Staff Report

Subject: **Bridge Street (36-015J) – Abbreviated Notice of Resource Area Delineation – DEP# 023-____, Fairhaven CON 023-251**

Re: Wetland Replication, Buffer Zone, & Stream Restoration Plan
20 Yankee Lane, Fairhaven, MA 02719 (Fairhaven Enforcement Order 023-014)

SITE LOCUS

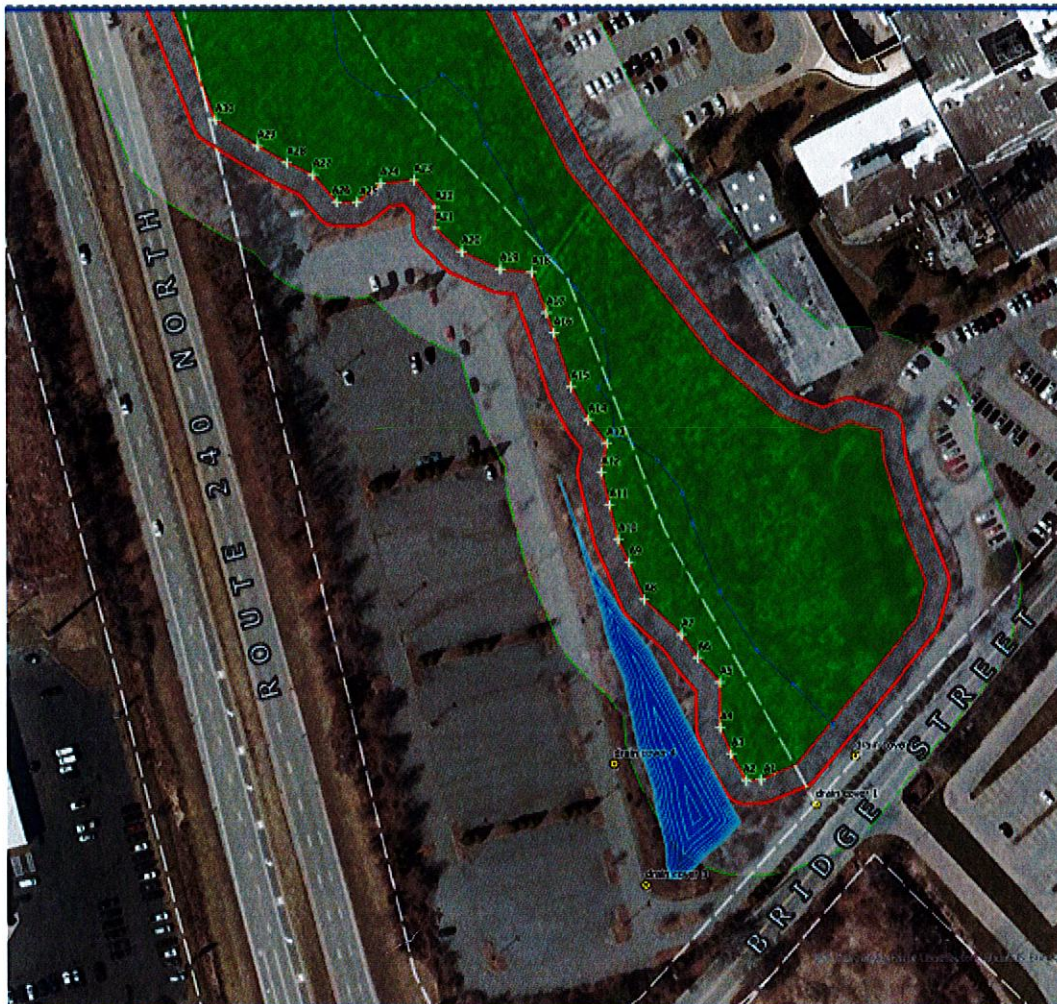
- The applicant submitted an ANRAD for 2,205 linear feet of BVW as well as 913 linear feet of bank.
- The Commission will need to determine whether they want peer review of the submission, especially since the USGS map shows the stream to be perennial rather than intermittent. No documentation has yet been submitted related to the status of the stream as intermittent.
- A deposit of \$2500 would be needed before initiating peer review based on the solicited quotes.
- MassDEP has not yet issued a file number, so the public hearing cannot yet be closed.

- If the Commission would like to see peer review for the project, I recommend voting to allow the Agent to coordinate the peer review process.

Figure 2. The location of the man-made stream to be removed.

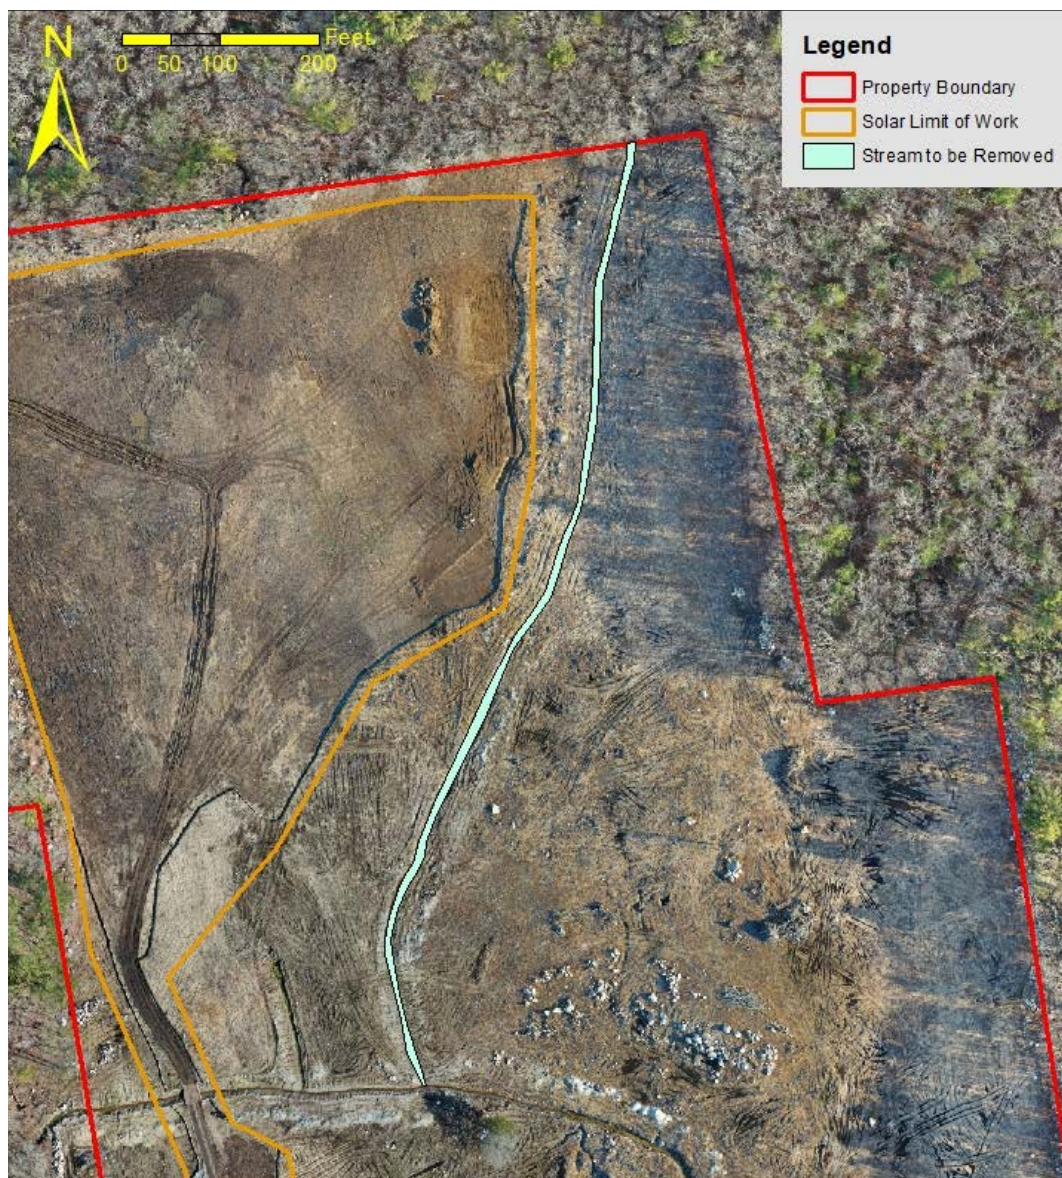
- There is a significant lack of detail regarding the removal of the manmade stream. How is it being filled? With what? Where is the access? What is the method of restoration for that area once the stream is discontinued?

There is a man-made stream on-site that was constructed. This stream will be filled in in order to allow the hydrology of the surrounding wetland to re-establish (see Figure 2).

Figure 5. The approximate locations of phragmites observed on-site to be removed.

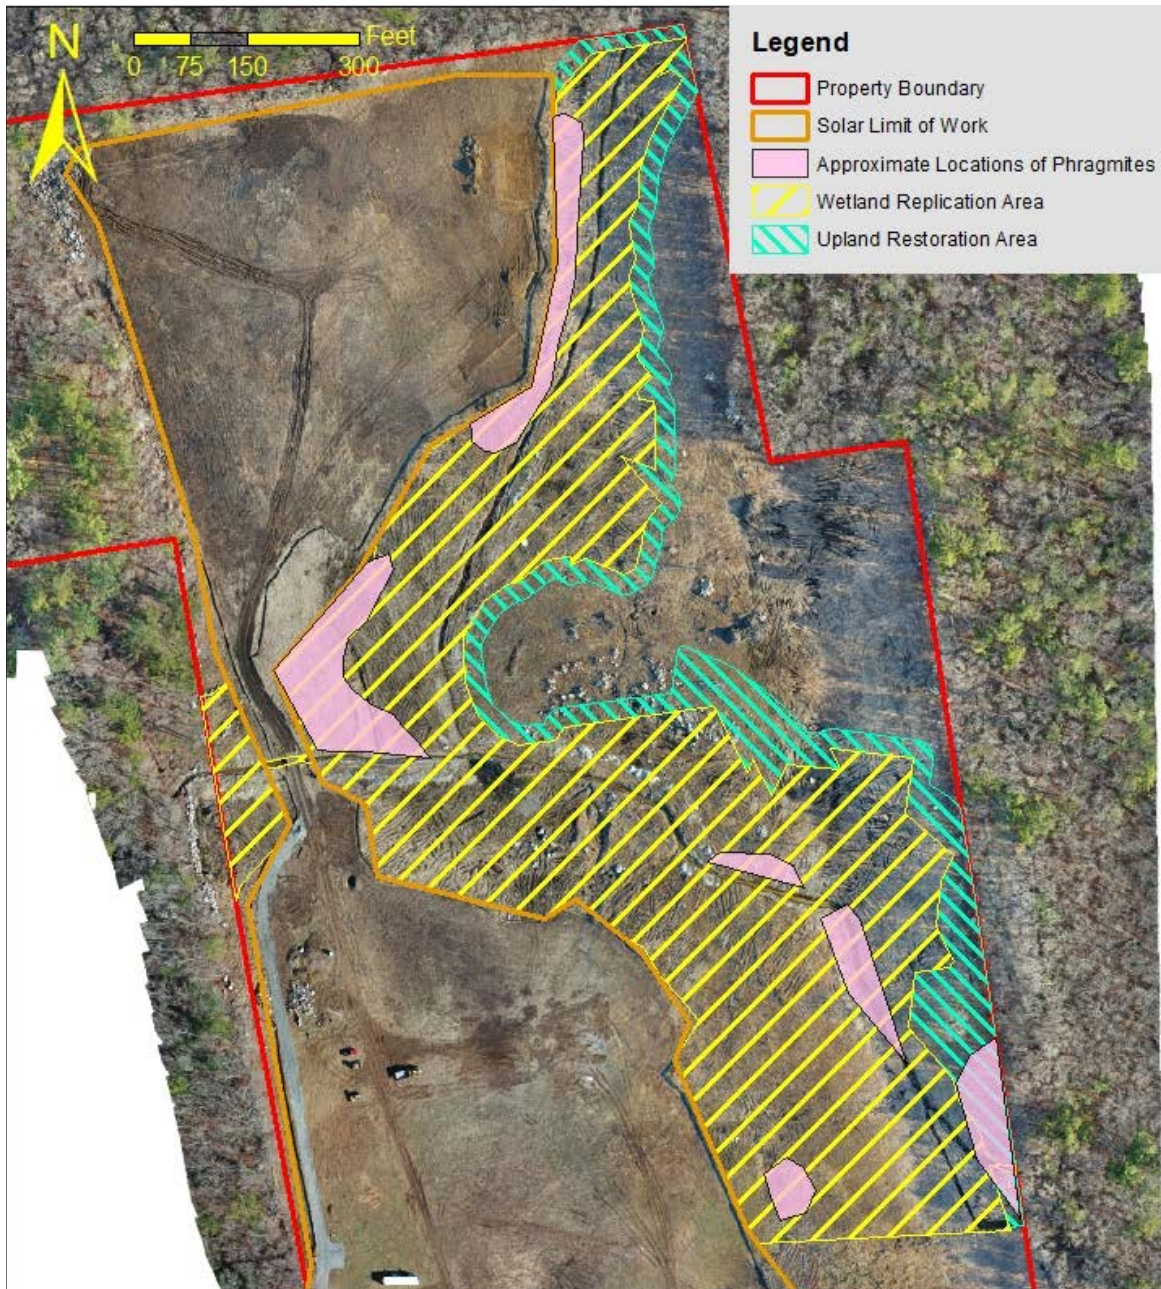
- An invasive species management plan also needs to be part of this restoration plan as there is *Phragmites* on site already.
- This should be a phased restoration plan both because it is a large area and because there are several facets to this project. Start with revegetation of areas that are not going to be disturbed by stream restoration, removal or fill, or equipment in the resource area. Include an access plan as to how you will get to the areas to be restored. A planting plan for areas that are not going to be disturbed by other restoration work can be presented to the Commission so planting may be able to occur this fall. That gives until the spring/summer for subsequent phases of the restoration work. If you are proposing to wait until a low-flow period for the stream restoration, other restoration work can and should be occurring in the meantime.

Phragmites have been observed to be present on-site in several locations (see Figure 4). These plants will be removed by an excavator and brought off-site to an approved facility for invasive species removal prior to any grading on-site. Any phragmites that occur within the restoration areas in subsequent inspections will be removed by hand or through the application of glyphosate, as approved by the supervising wetland scientist.

Figure 9. The locations of the areas to be seeded, the entirety of the wetland replication and the upland restoration areas, including the area to be plan.

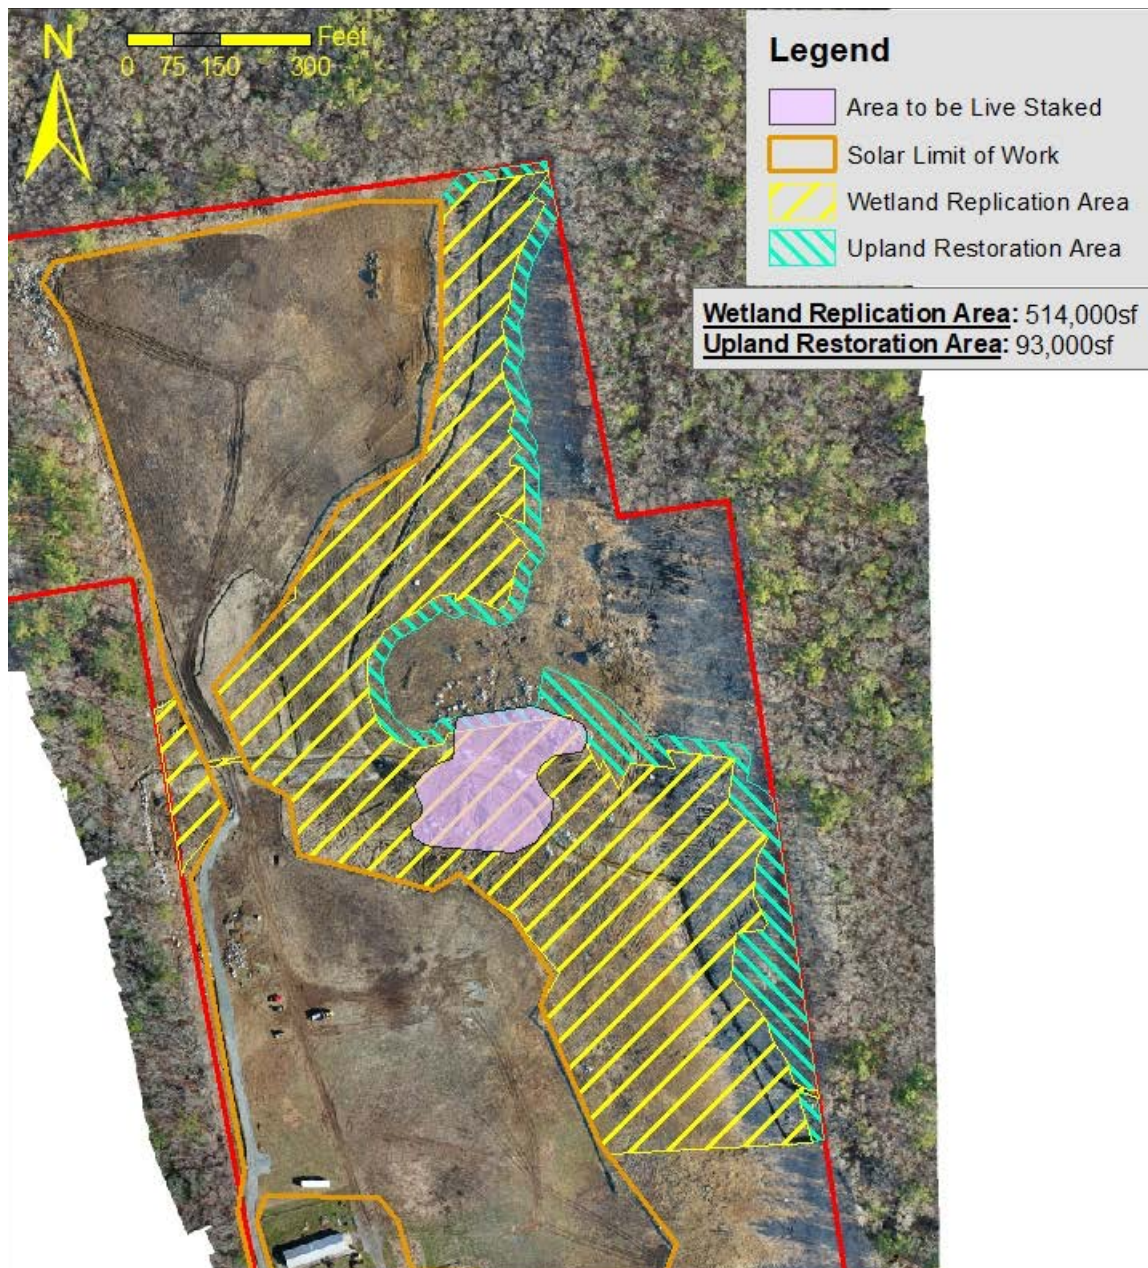
- The proposed seed mix is also identified as a Pennsylvania ecotype. This is inappropriate for Massachusetts. Additionally, there should be some shrub and tree plantings proposed, especially if early succession had started in the area. Using the higher end of spacing as outlined in MassDEP's Massachusetts Inland Wetland Replication Guidelines is fine, i.e. 10 feet on center for shrubs and 15 feet on center for trees. If herbaceous cover is already 75% or more, seeding is not necessary in those areas. This will allow some of the expense of purchasing seed to be shifted to planting some trees and shrubs. Areas that don't have good herbaceous cover will need to be seeded, including areas that are disturbed for restoration purposes.
